Bulletin No: 2019 MJ01 - Rev. 01

SERVICE BULLETIN

Ride Name: Mini Jet

Align older rides with most current non-destructive testing (NDT) and replacement schedule.

IMAGE 1 - VEHICLE SUPPORT

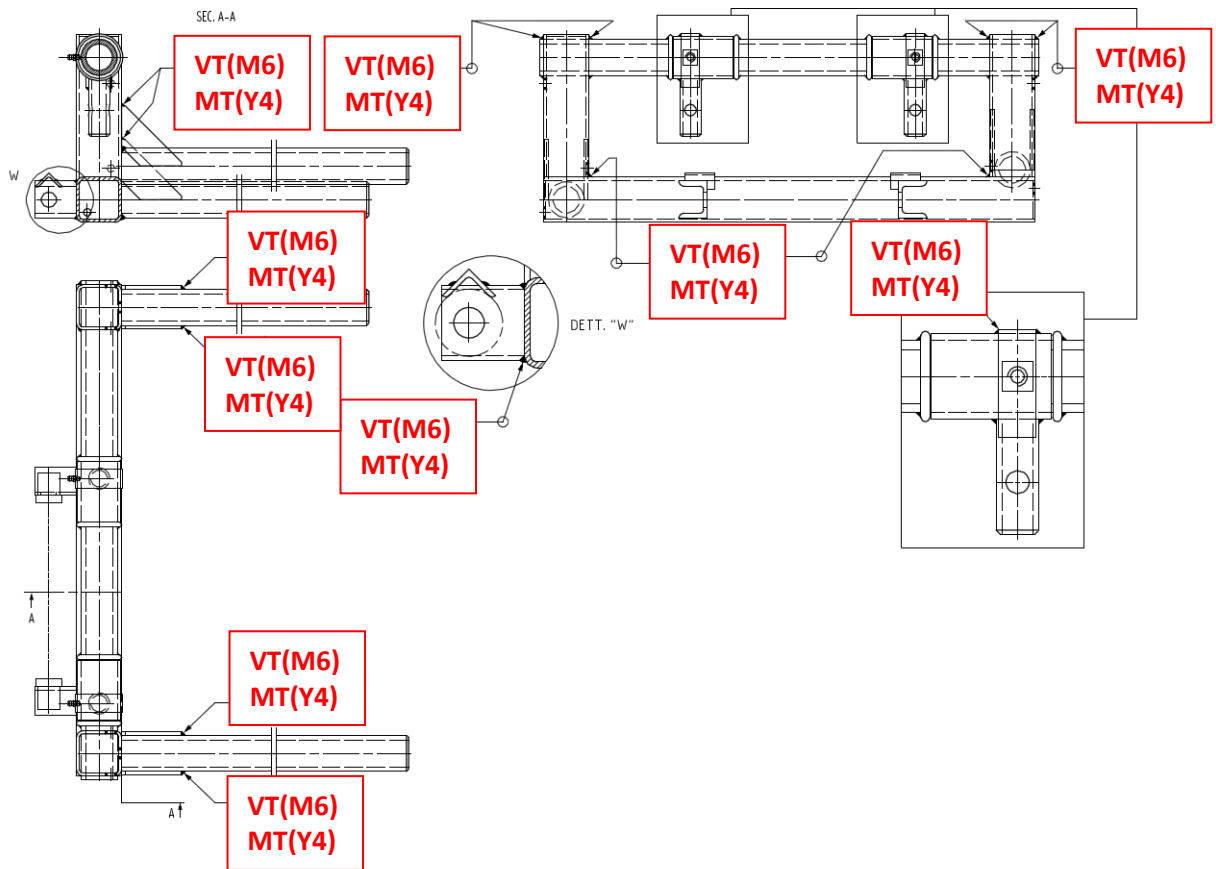
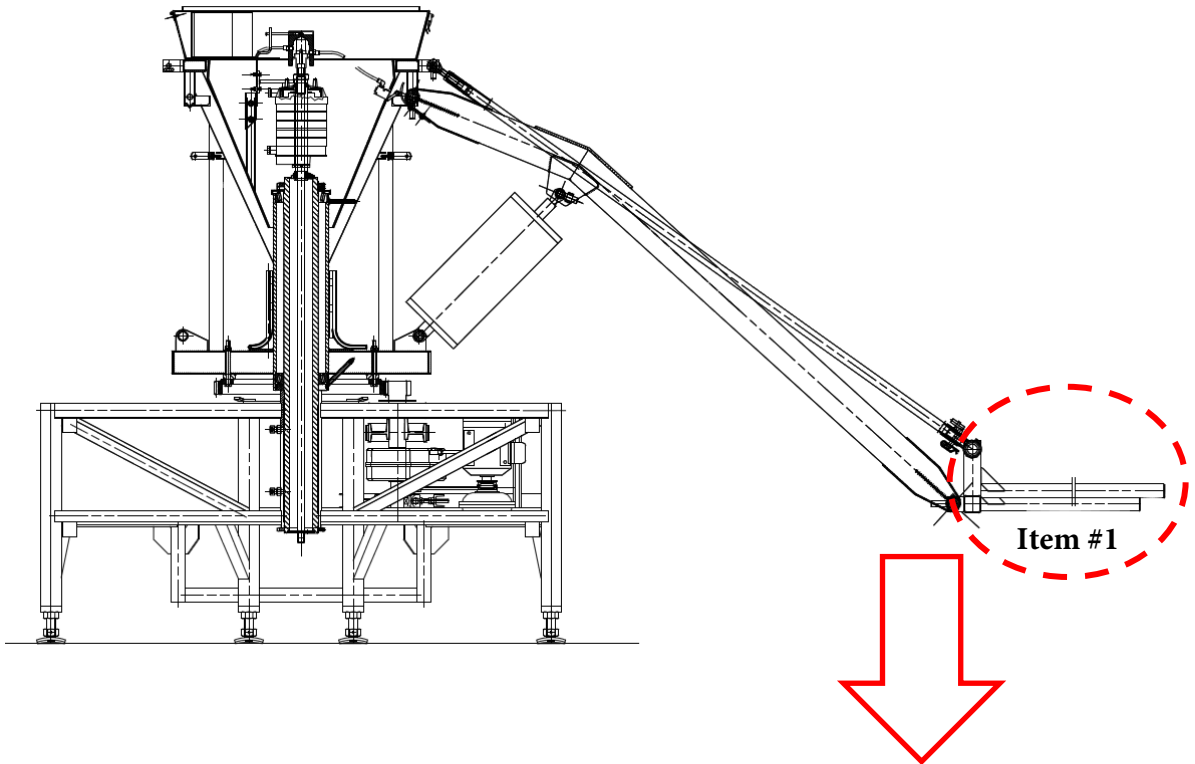
| Item | Part Number | Component and Location | Image # | Test method code | Test every (Time Code) | Remarks |
|------|-------------|------------------------|---------|------------------|------------------------|---|
| 1 | | Vehicle Support | 1 | VT | M6 | Check welds. Check for cracks, corrosion. |
| | | | | MT | Y4 | |

IMAGE 2 - TIE-ROD AND ARM PINS

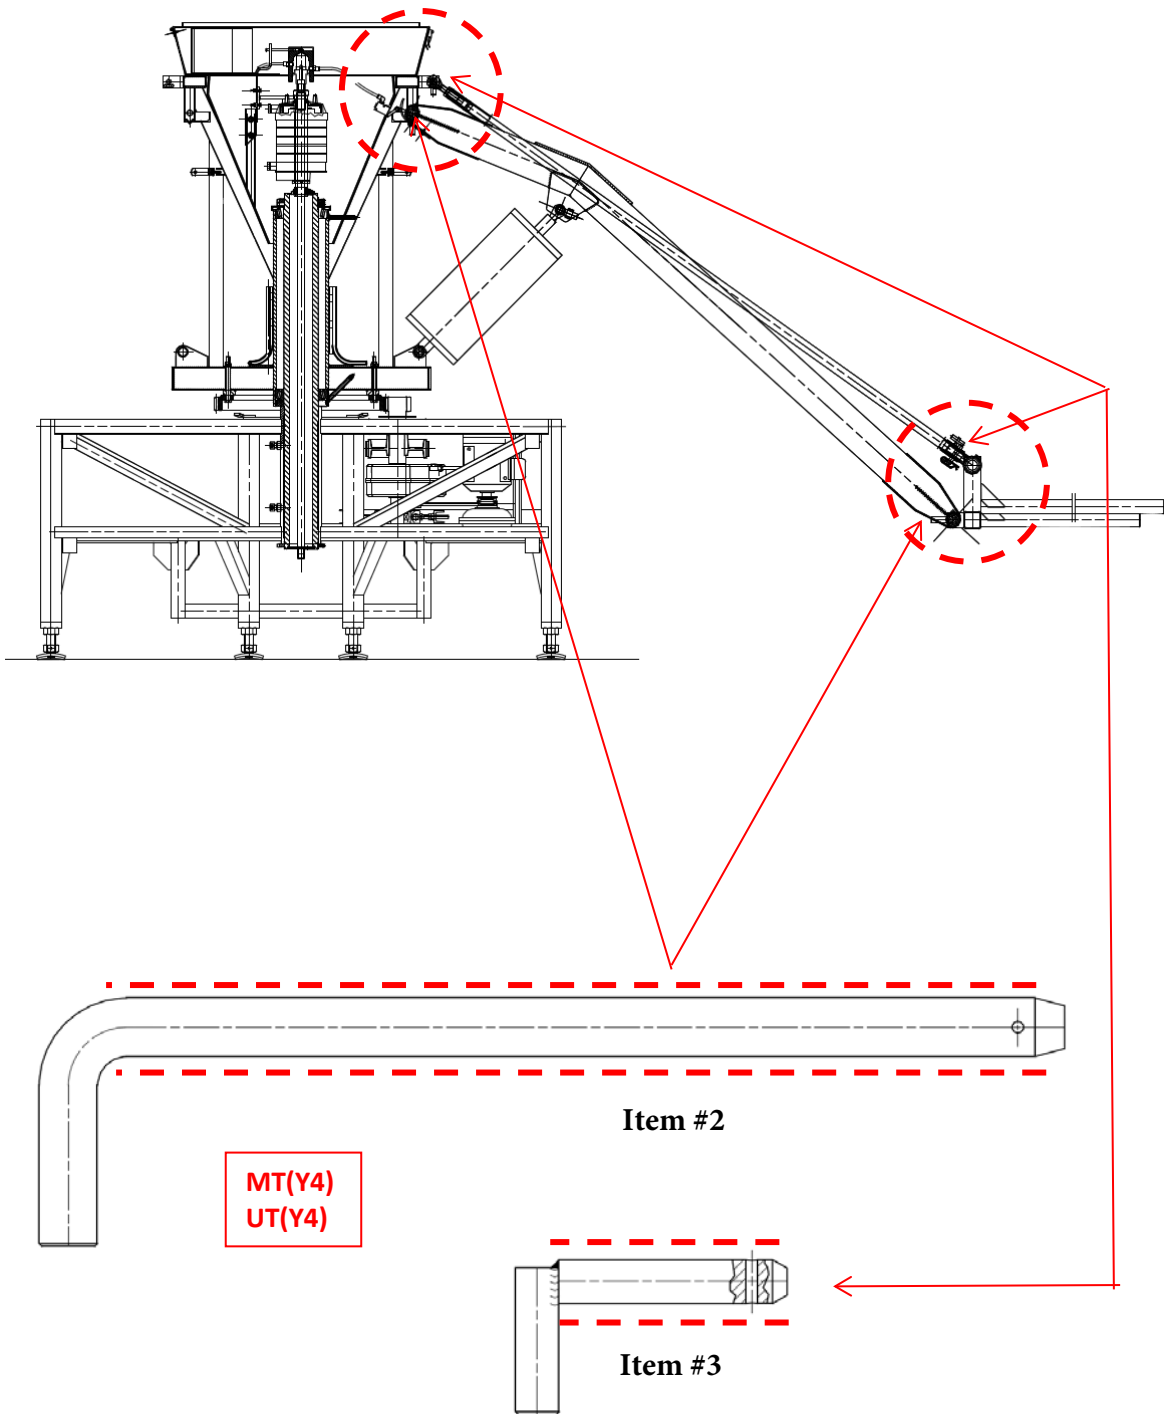
| Item | Part Number | Component and Location | Image # | Test method code | Test every (Time Code) | Remarks |
|------|-------------|------------------------|---------|------------------|------------------------|---|
| 2 | | Tie-Rod Pin | 2 | MT | Y4 | Check for cracks, corrosion. |
| 3 | | Arm Pin | 2 | MT | Y4 | Check for cracks, corrosion. |

| Item | Part Number | Component and Location | Image # | Replacement every [no. of years] |
|------|-------------|------------------------|---------|----------------------------------|
| 2 | | Tie-Rod Pin | 2 | 12 years |
| 3 | | Arm Pin | 2 | 12 years |

IMAGE 3 - TIE-ROD

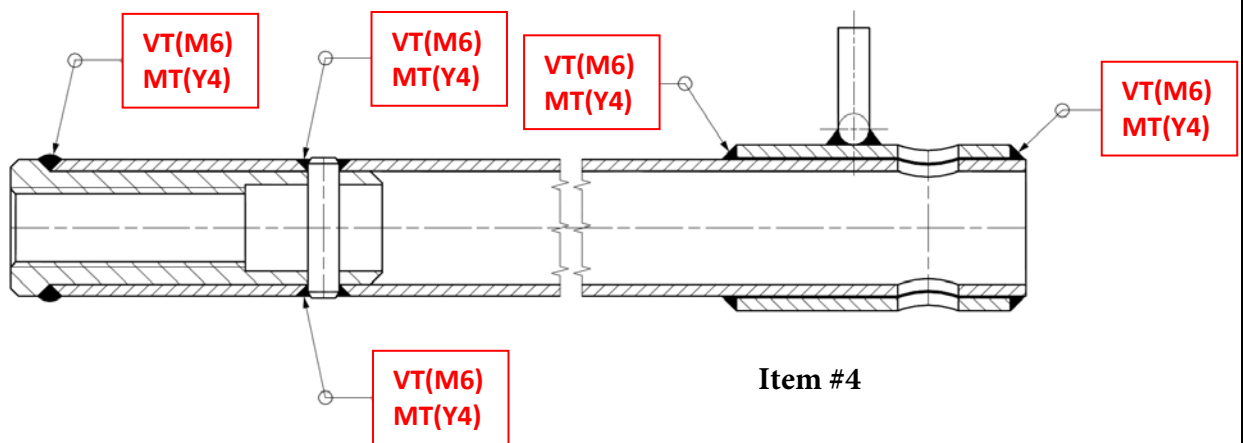
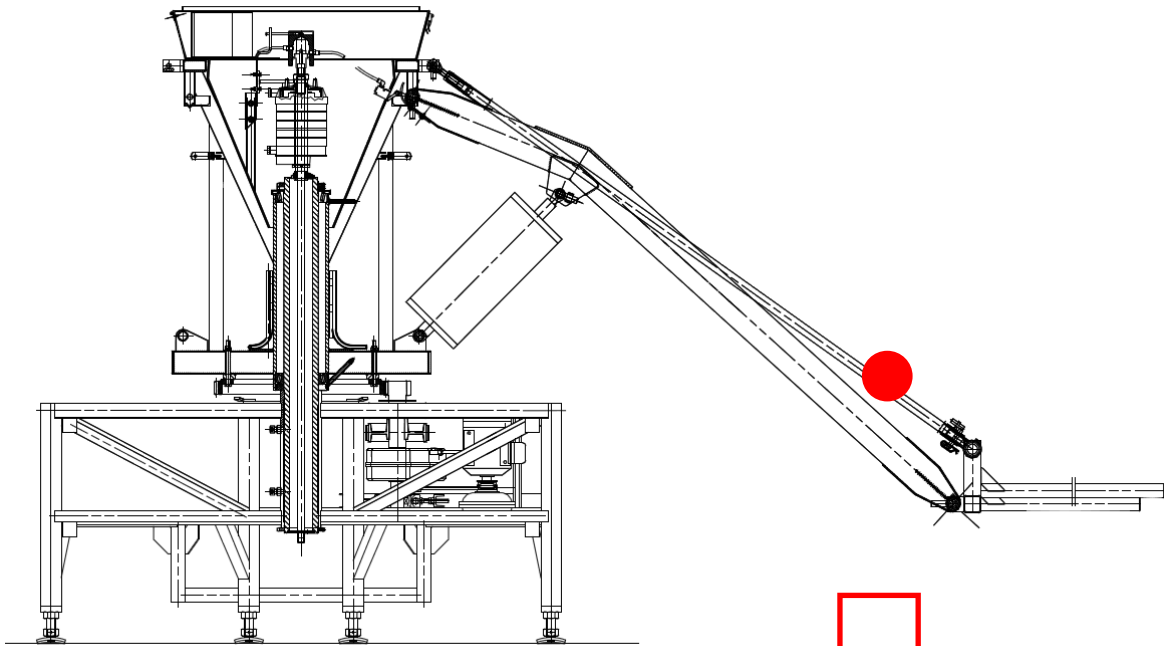
| Item | Part Number | Component and Location | Image # | Test method code | Test every (Time Code) | Remarks |
|------|-------------|------------------------|---------|------------------|------------------------|---|
| 4 | | Tie-Rod | 3 | VT | M6 | Check welds. Check for cracks, corrosion. |
| | | | | MT | Y4 | |

IMAGE 4 - ARM

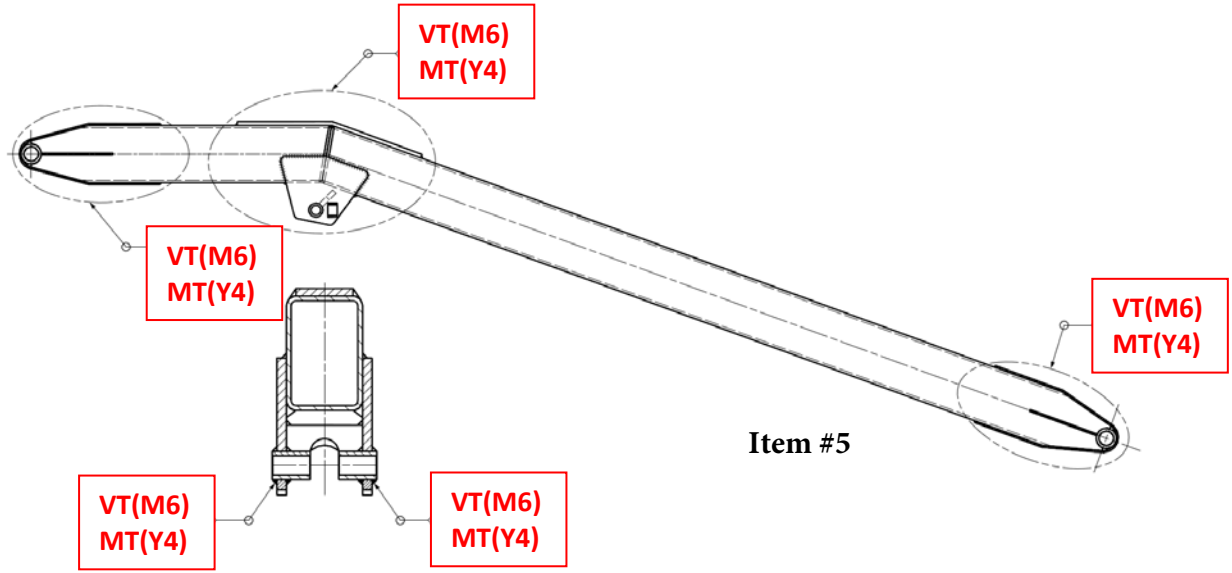
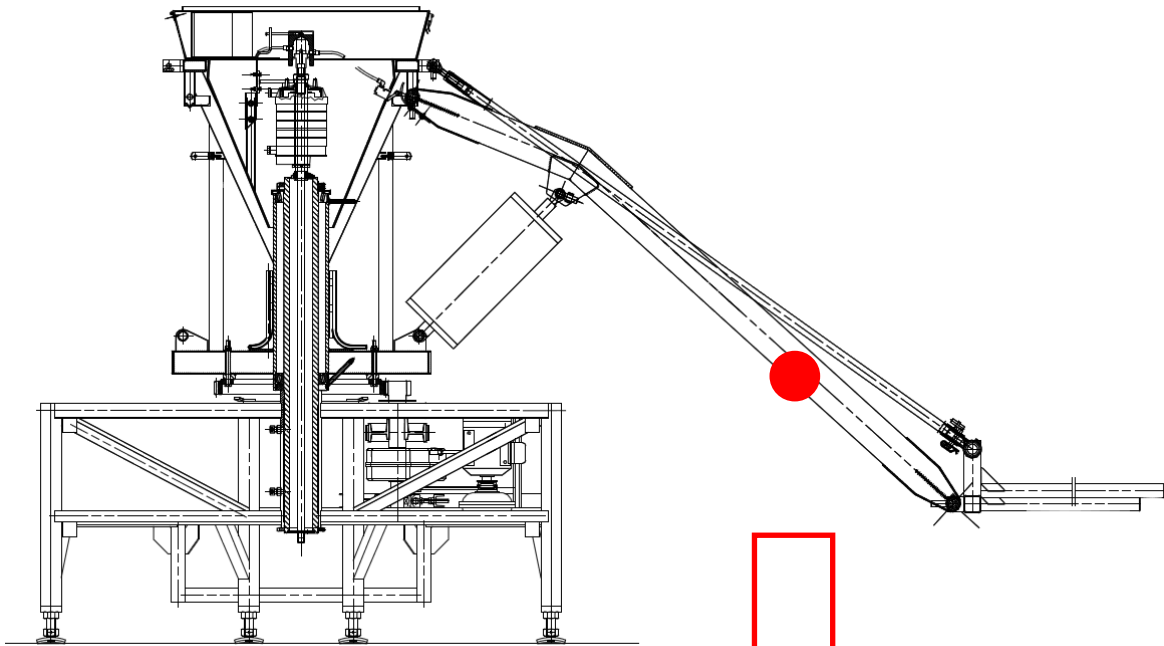
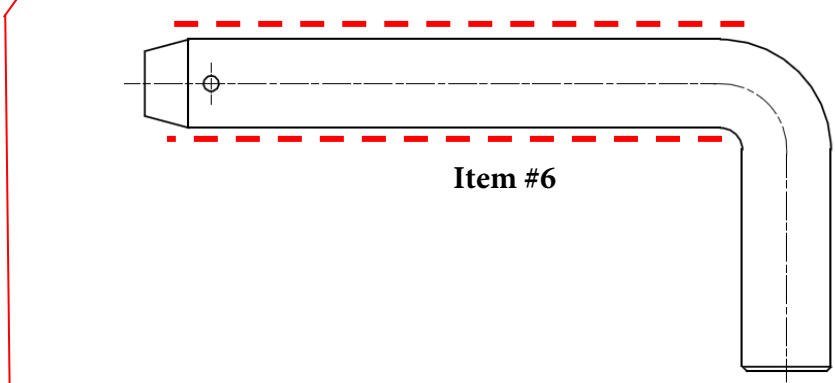
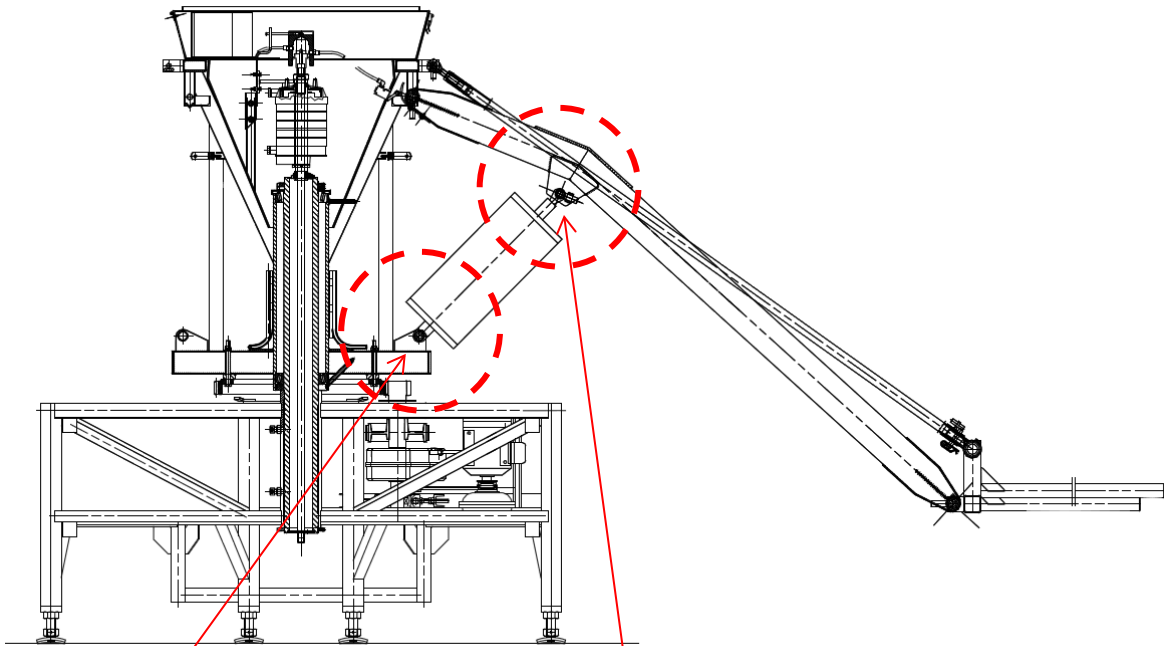
| Item | Part Number | Component and Location | Image # | Test method code | Test every (Time Code) | Remarks |
|------|-------------|------------------------|---------|------------------|------------------------|---|
| 5 | | Arm | 4 | VT | M6 | Check welds. Check for cracks, corrosion. |
| | | | | MT | Y4 | |

IMAGE 6 - ROTATING CENTER

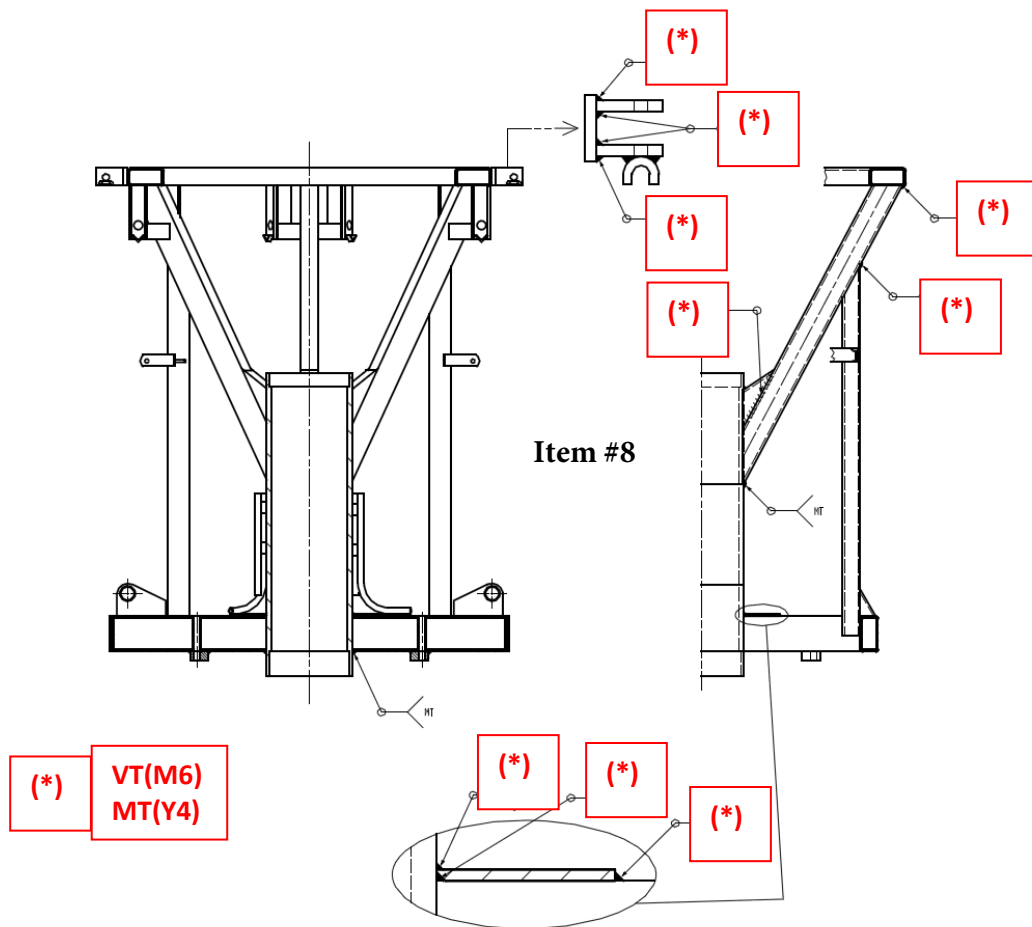
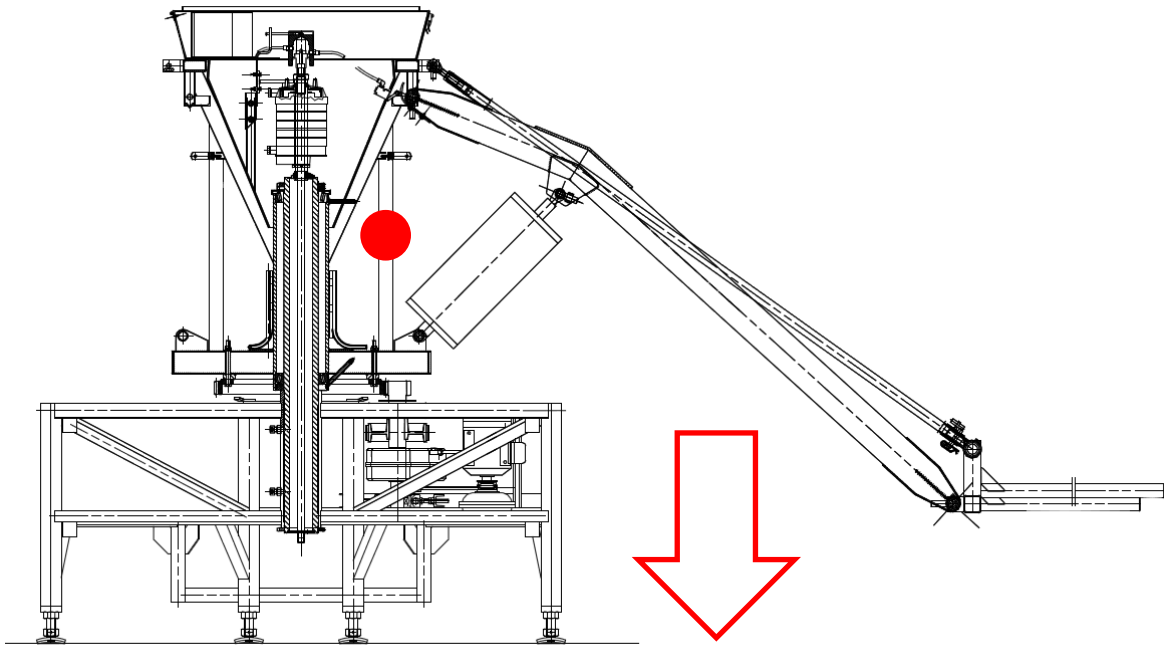
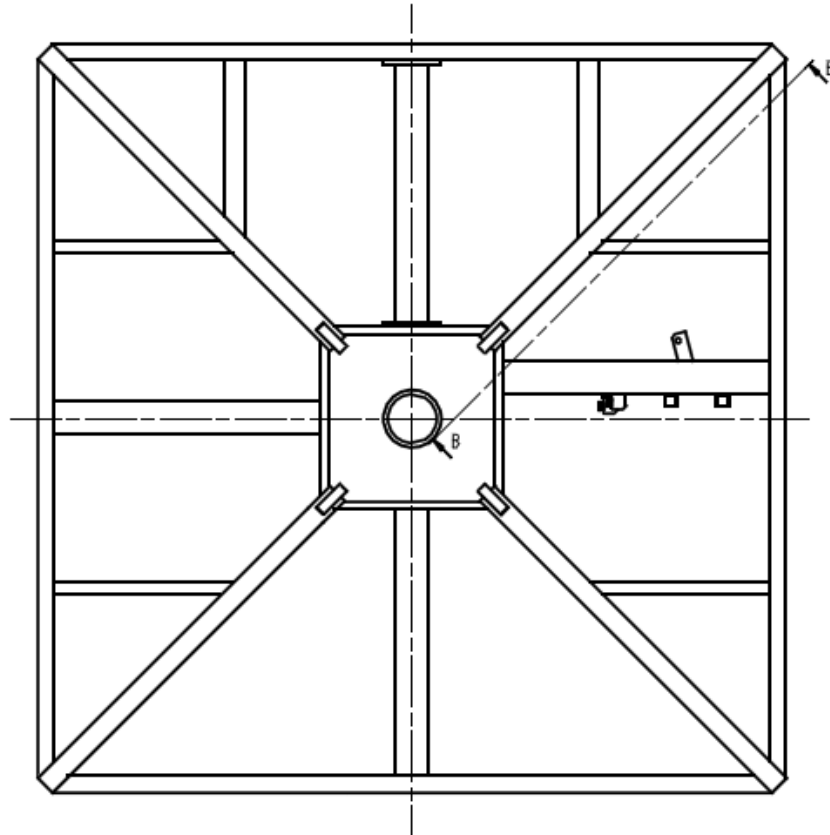
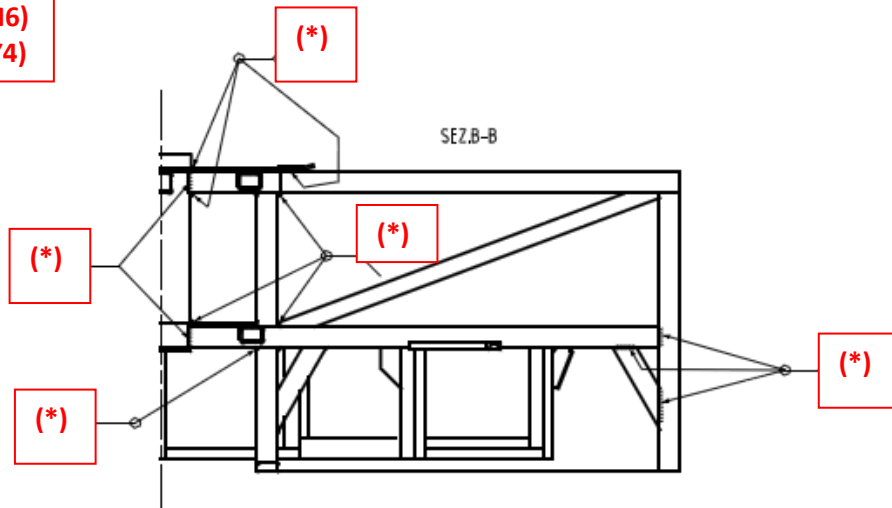
| Item | Part Number | Component and Location | Image # | Test method code | Test every (Time Code) | Remarks |
|------|-------------|------------------------|---------|------------------|------------------------|---|
| 8 | | Rotating Center | 6 | VT | M6 | Check welds. Check for cracks, corrosion. |
| | | | | MT | Y4 | |
